DeKalb County Department of Planning & Sustainability

STAFF ANALYSIS

Case No.:	Z-22-1246091	Agenda #: 2022-2261
Location/Address:	8067 Rockbridge Road	Commission District: 04 Super District: 07
Parcel ID(s):	16-193-03-011	
Request:	Rezone from R-100 (Residential Medium Lot-100) Zoning District to C-1 (Local Commercial) Zoning District to allow the construction of a convenience store.	
Property Owner(s):	Subhans Venture, LLC	
Applicant/Agent:	Mahek Virani	
Acreage:	0.38 acres	
Existing Land Use:	Undeveloped	
Surrounding Properties:	North: C-1 East: R-100 South: R-100 West: R-100	
Comprehensive Plan:	SUB <input type="checkbox"/> Consistent	<input checked="" type="checkbox"/> Inconsistent

Staff Recommendation: Disapproval.

CONCEPT
 SHEET C01

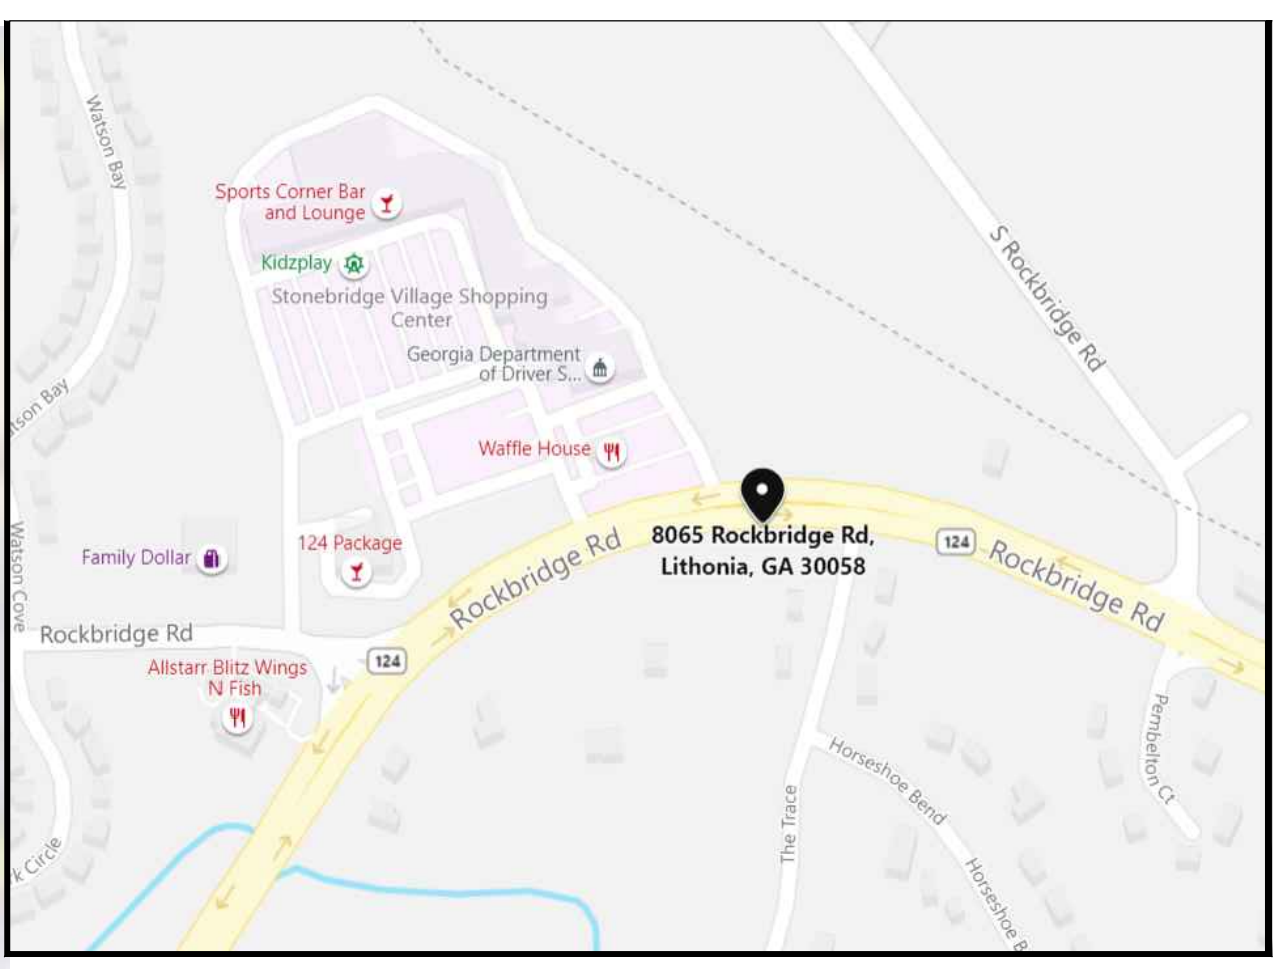
Upon review of the proposed site plan, at approximately 16,362 square feet (0.38 acres), the subject property would be smaller than the C-1 minimum lot area of 20,000 square feet. The development plans do not include the proper minimum setback requirements (50ft-front & side corner, 20ft-interior side, 30ft-rear). The lot would not support the proposed commercial use and the minimum 50-foot transitional buffer adjacent to residentially zoned lots. Furthermore, the subject property was designed as a residential lot, therefore, its primary frontage is along The Trace; not Highway 124.

The Department of Public Works does not recommend commercial access from The Trace. Also, the property is situated along a curve, which further complicates ingress/egress and vision clearance. On-site stormwater detention has not been addressed. This site may not be adequate for the proposed zoning and uses.

Conceptual plan doesn't indicate the location of the stormwater management facility. Location of stormwater management shall be shown or compliance with the County stormwater management regulations shall be explained.

Runoff Reduction Volume shall be provided unless technical justification is provided regarding the unfeasibility. Strongly recommend investigating the site and identify location where RRv can be provided and re-design/revise the layout to comply with the RRv requirement.

However, a state water determination request must be submitted to the County to confirm that the ditch that is running through the property is not a creek/state water with buffer; before moving forward.
